UPDATES AND ANSWERS TO THE REVIEWERS' COMMENTS

The authors of "Flying through the plasmasphere to optimize low energy ion measurements" utilize the Juice spacecraft's flyby of Earth to improve the measurement scheme of the JDC instrument. Observations from the low-energy plasmasphere revealed that the voltage stepping of the instrument differed substantially from expectation. Performing laboratory experiments with the ground-copy of the instrument, the authors demonstrate that the observations can be correctly re-ordered to remove these stepping artifacts, which are further validated by a simple numerical model of the expected plasmasphere observations. Understanding the origins of the stepping issue, the authors present new voltage stepping patterns to maximize the scientific return of the JDC instrument during Juice's primary science mission at the Jovian moons. This work highlights the value of in-flight calibration to identify, understand, and

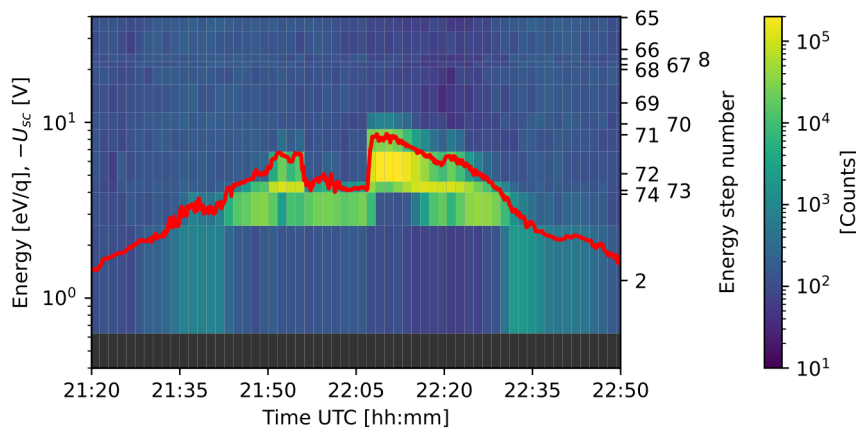
- Can the authors comment on the systematically low count rate below ~ 1 eV in Figure 5? The numerical simulation of the plasmasphere (Figure 7) suggests large fluxes may be present at these energies. Since the manuscript discusses the comparison between the re-ordered observations and the numerical simulation results, including the "holes" in the flux (line 225), it would be valuable for readers to understand if the low count rate in Figure 5 below ~ 1 eV is expected to be related to the actual plasmasphere (e.g., differences in ion species and temperatures) or an instrumental feature (e.g., related to geometric factor).

Firstly, Figure 5 contains a plotting mistake: bin 72 is plotted twice, the lowest energy bin should be shown as NaN values in the reconstructed spectrum (there was no energy bin below 1 eV, as shown in Figure 4). For visual impression, the colour bands fill the space between two energy bin centres, even if the energy difference between two bins is larger than the energy resolution. Below is the corrected Figure 5 including the correct unit counts, and not counts per second (cf. Technical correction below).

Secondly, the model we use is extremely simple. At energies below 1 eV it is not expected that the model will reproduce the measured data. Any protruding spacecraft structure like solar panels or any booms will result in near spacecraft ion trajectories that are significantly different from those obtained near a point-like spacecraft as in our model. Model fluxes may thus differ from the observed ones at these energies. We added a few sentences in section 7 to stress this in the paper: *At energies below 1--2\,\unit{eV}, the true shape of the spacecraft significantly affects the trajectories of particles reaching the detector. The point-like spacecraft used in our model cannot reproduce these effects and model results likely differ from observations.*

Figure 3:

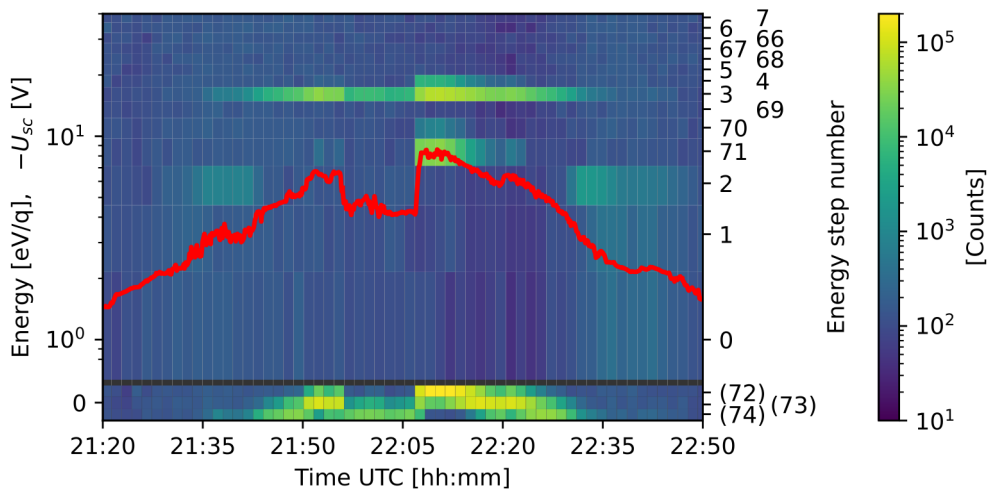
- To aid in readers' mapping the different voltage stepping presented in Figures 3-5 it is recommended that the vertical range in Figure 4 is lowered. Comparing Figures 3 and 5, voltage step 73 exhibits a substantial re-ordering from ~ 0.1 eV in Figure 3 to ~ 4 eV in Figure 4. Since this step contains some of the highest count rates it would be valuable for readers to compare the expected vs. actual voltages in Figure 4, however, this is below the vertical axis of the plot.

- It should be clarified if Figures 3 and 5 show counts (as listed in the figure caption) or counts-per-second (as suggested by the "cps" label). Showing counts would be helpful to readers since it illustrates the instrument sensitivity (e.g., the 1-count limit) and uncertainty (e.g., Poisson).

The energy steps 72-74 in Figure 3 and 4 were nominally at 0 eV and could thus not be represented on the logarithmic scale. We harmonized the vertical axes on Figures 3-5 and added a note to the caption of Figures 3 and 4:

Figure 3:[...] *The corresponding tick-marks on the right-hand vertical axis correspond to the intended energy bin centre. For energy steps 72-74 the intended centre was 0 eV.*

The units in Figures 3 and 5 are counts. The figures were corrected in this regard (see updated figures above).
